DATE: June 15, 2022
 AGENDA ITEM #4

TO: Design Review Commission
FROM: Nazaneen Healy, Associate Planner
SUBJECT: SC22-0002 – 632 Leaf Court

This is a design review application for a new 3,878 square-foot two-story single-family residence. The project includes 3,171 square feet on the first story and 707 square feet on the second story. This project is recommended to be considered categorically exempt from further environmental review under Section 15303 of the California Environmental Quality Act since it involves the construction of one single-family residence in an area zoned for residential uses. The following table summarizes the project’s technical details:

SHEET
 A0.0

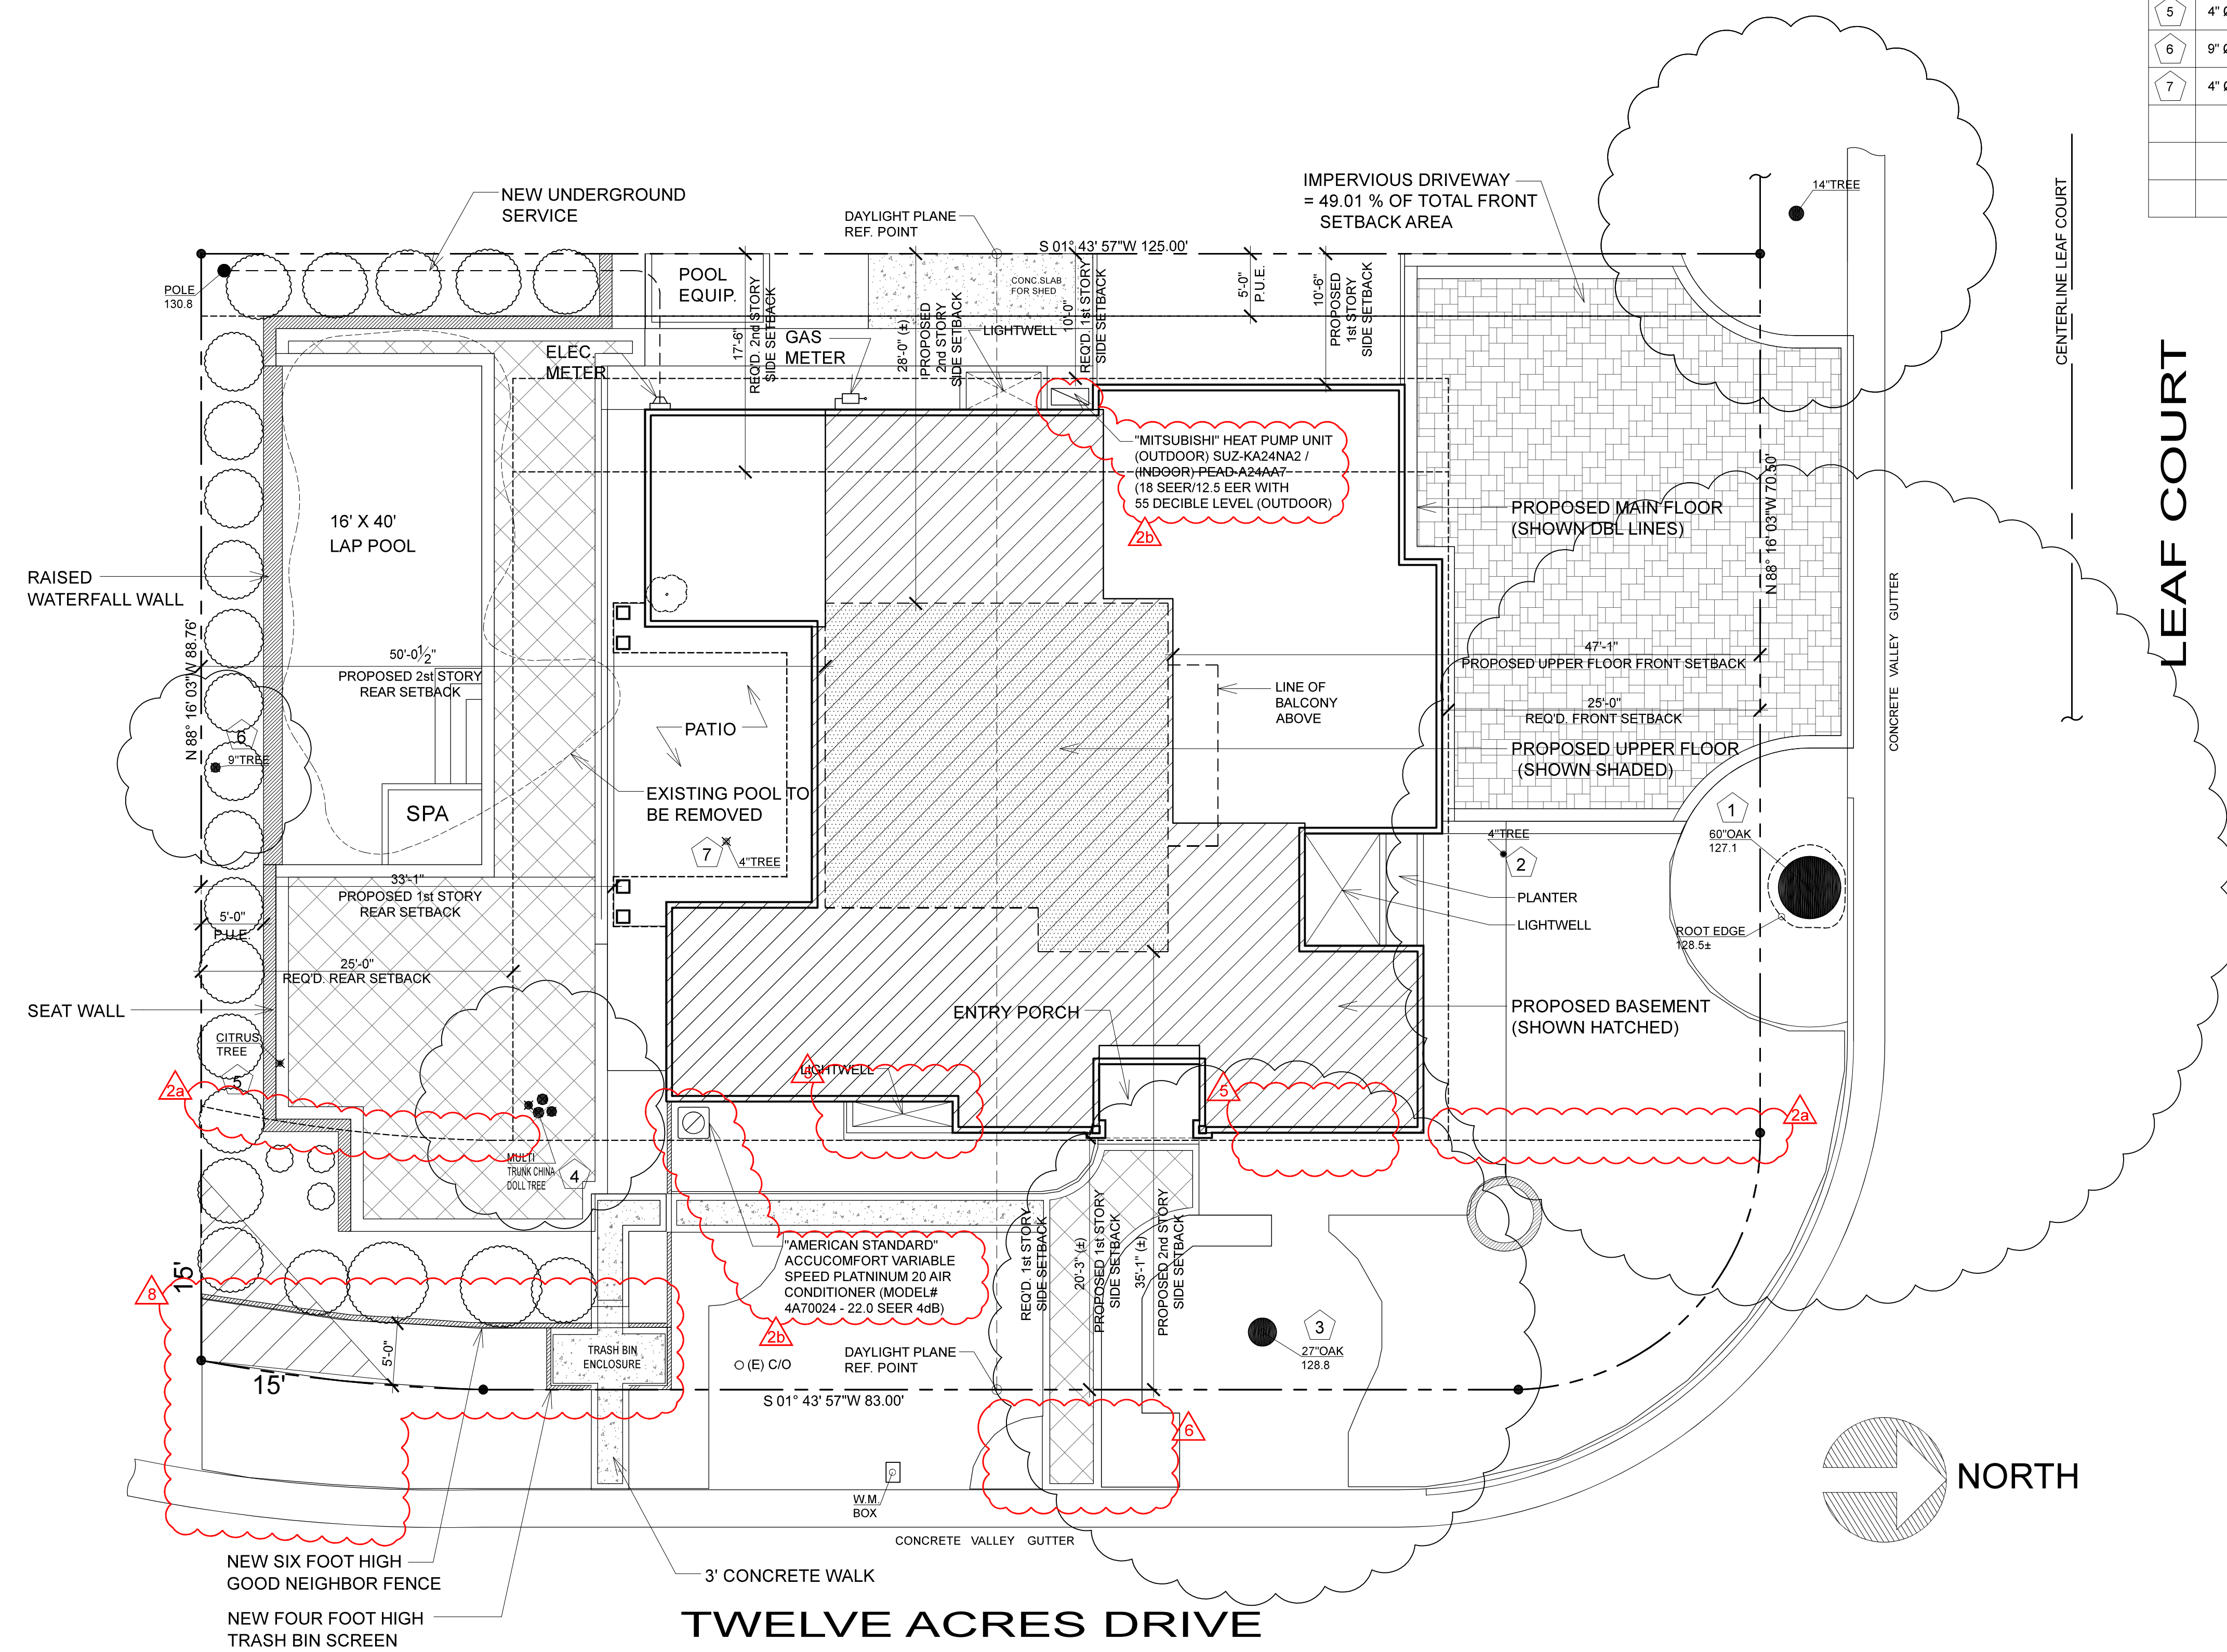
- a. On the Site Plan and Landscape Plans modify the location of the 6-foot tall fencing proposed along the exterior side property line to provide the 15-foot sight triangle required for an adjacent property's driveway within 15 feet pursuant to LAMC Section 14.72.020.

- b. On the Landscape Plans extend the proposed rear yard screen tree plantings along the rear property line to the planting area along the interior side property line.

PROPOSED BASEMENT PLAN

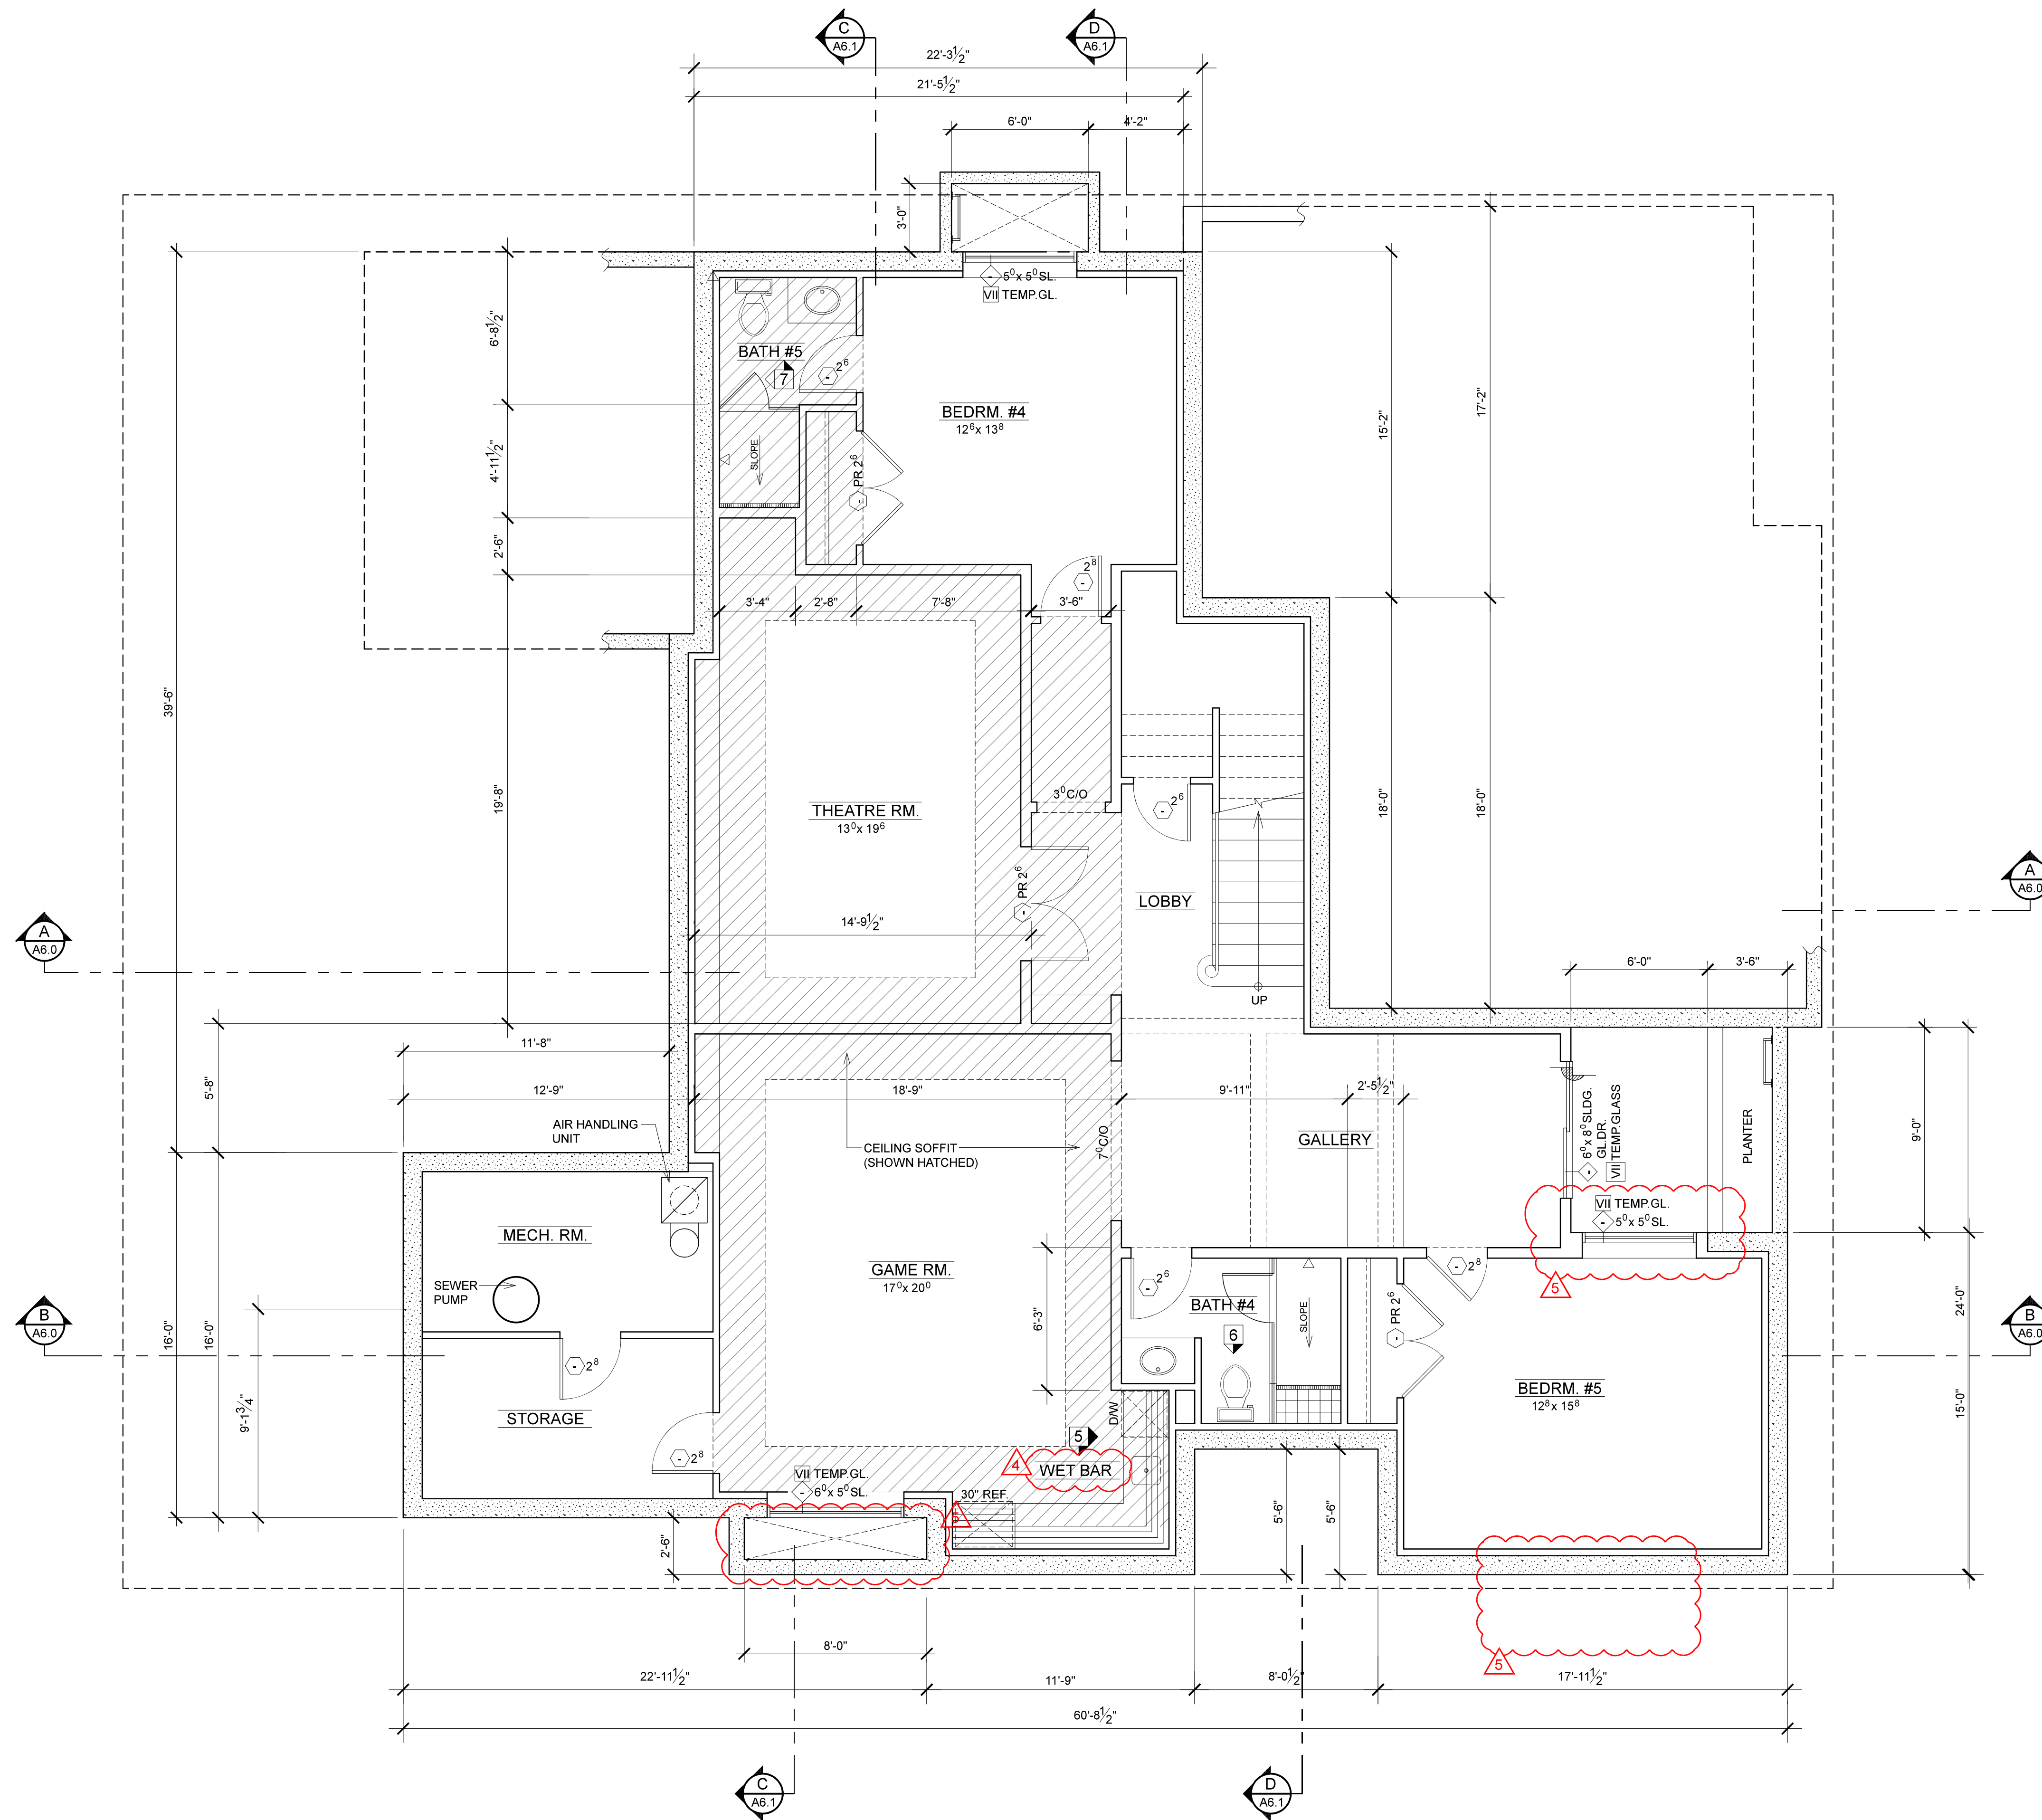
- c. On the Basement Floor Plan add a note indicating: "Wet bar. This area shall not be used as a kitchen. No cooking appliances shall be installed or used in this area."

- d. On the Basement Floor Plan label the mechanical room and storage room as nonhabitable space.
- e. Provide a Shoring Plan for the basement excavation that minimizes potential impacts to the protected trees. The shoring plan shall identify the locations of vertical cuts, slopes, and stitch/shoring piers in relation to the protected trees and cross section detail(s) of the shoring. If potential impacts to trees are identified which include excavation within two-thirds of the dripline, an arborist evaluation may be required to provide recommended design or mitigation measures to reduce impacts to trees.
